GEOSHIELD Verification Report

GEO101021

002

McAlear & Rushe

LOCATION/GRID LINE: Pile cap on A10

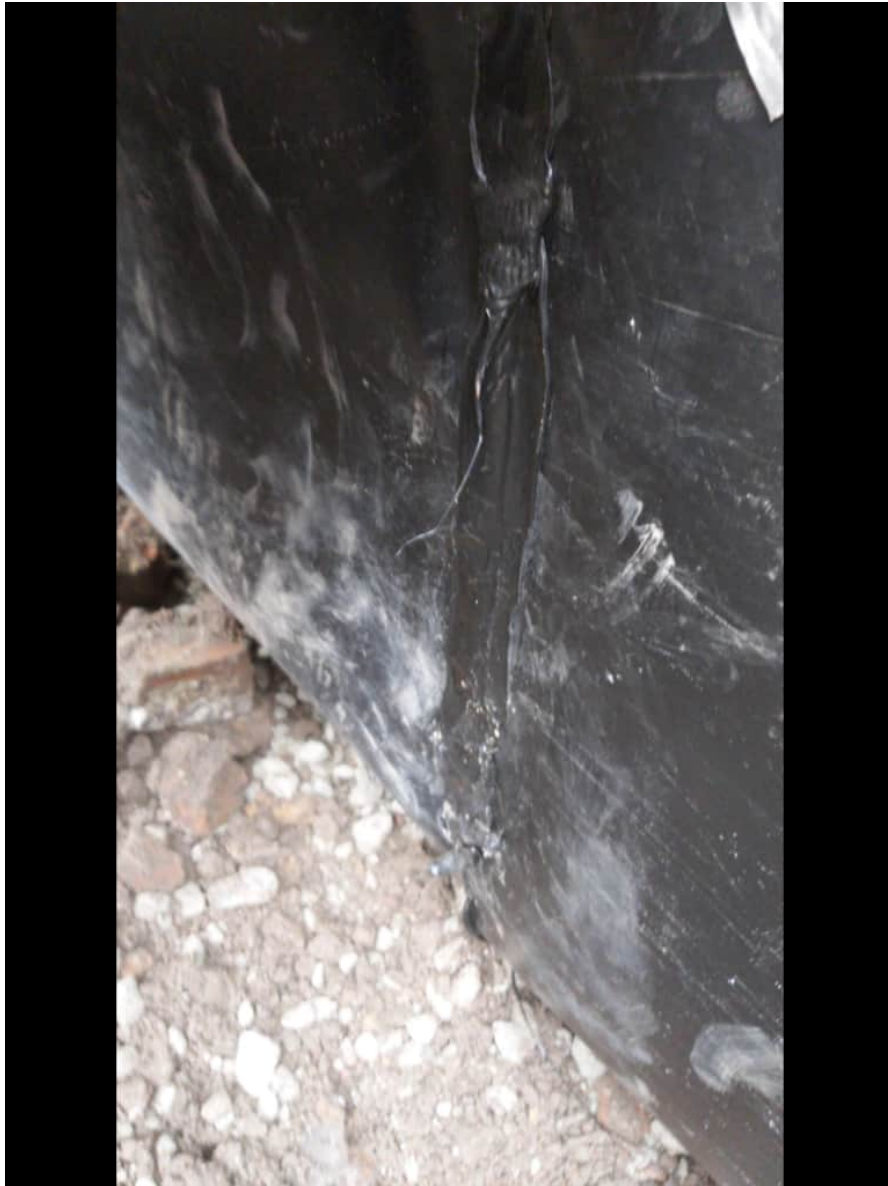
NOTES: Pile cap on A10 wrapped with Visqueen Ultimate

Geoseal with joints hot welded and extrusion welded. Correct spacers used and membrane lapped under pile cap 200mm as per design detail.

1. Steel rebar covered with tric trac spacers before being wrapped

2. Pile cap wrapped with Geoseal and sealed with extrusion welds

LOCATION/GRID LINE: Core D7 and D5

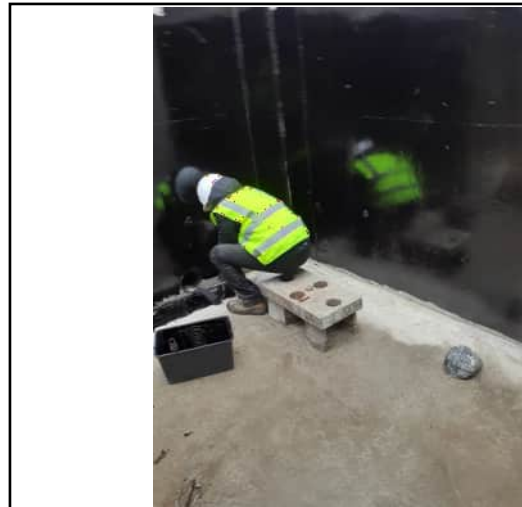
NOTES: Core D5 is now complete. Core D7 is on going and

requires water removing from the base to allow a good seal with the GR SAM.

Further prep works required on D7 as done with D5

1. Base of D5 swept clear of standing water and dried with a blow torch.

2. Base of D5 dry enough for bitumen primer before GR SAM applied.

Pick and probe test carried out to D7

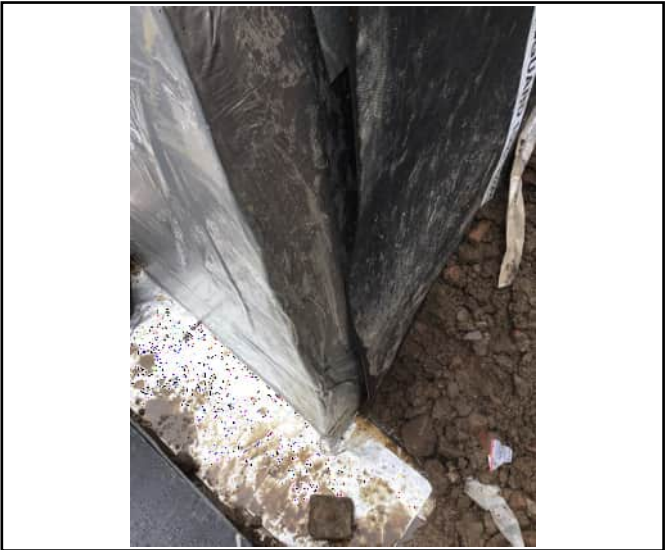
Good overlaps used in D7 core
